2021/3018/P – Land to the rear of 2-4 Shoot Up Hill, London, NW2 3QN

| Delegated Report (Members Briefing) | | Analysis sheet | | Expiry Date: | 29/12/2021 |
| Demolition of the existing single storey buildings (Class B2) on the site and the erection of a four storey residential block (Class C3) to provide 6 new units with associated landscaping, cycle parking and amenity space. | | | | | |

Ground and First Floor Plans

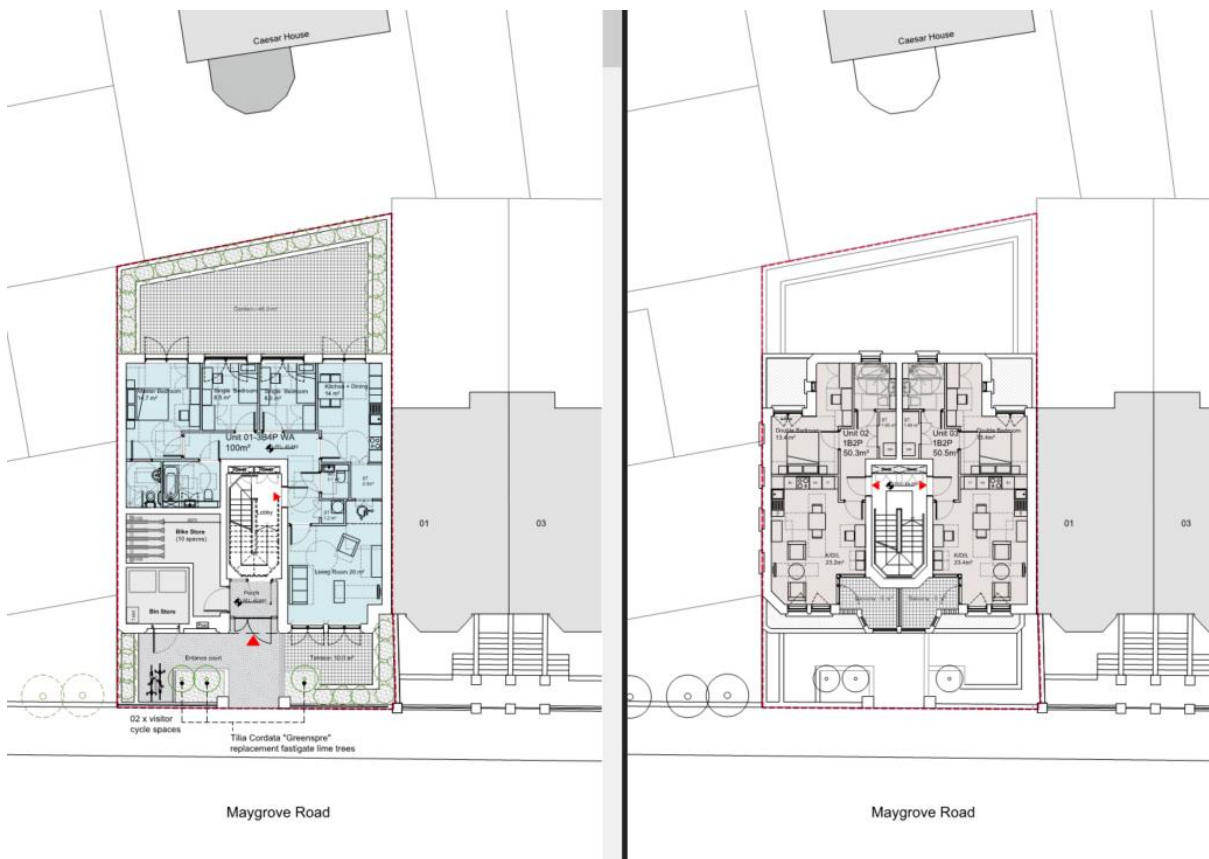
- 1.4. Revisions:
 - 1.4.1. Officers requested design amendments to the ground floor which was considered harsh in relation to the upper floors and they read as two different structures. To soften this relationship and to provide more of a link between the two, the corners have been chamfered and some perforated brick from the upper flows have been included on the ground floor.

2.5.2. Since pre-application discussions, a basement was removed from the proposal along with other design alterations. As part of this application, the design at ground floor was slightly altered and included the chamfered corners which reduced the overall mass and scale of this section. Now the current design reads a lot softer, integrates better with the upper floors and respects the surrounding area's character.

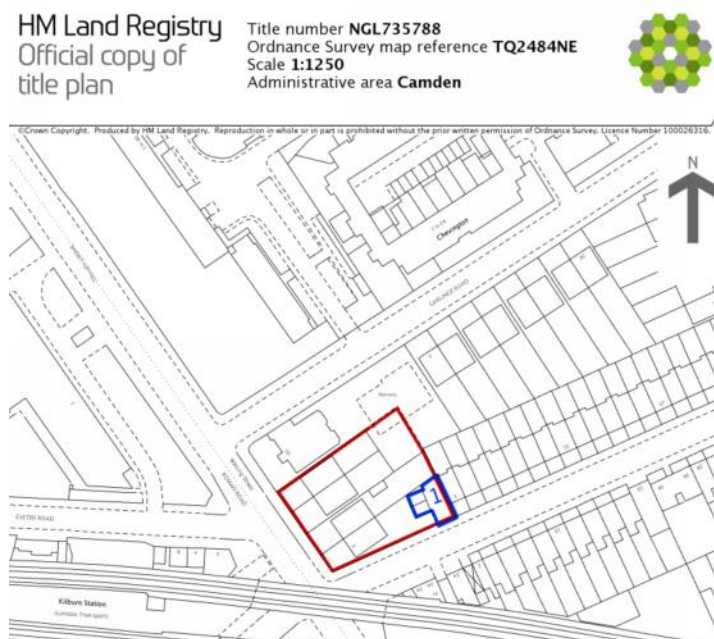
Upon land registry documents sent over to officers, the rear gardens of 2-4 shoot up hill are confirmed to be owned by the applicant. The Land Registry Title NGL735788 confirms that the freehold owner of the whole site of 2-8 Shoot up Hill, which includes the existing garage, is the applicant. (see screenshot below)
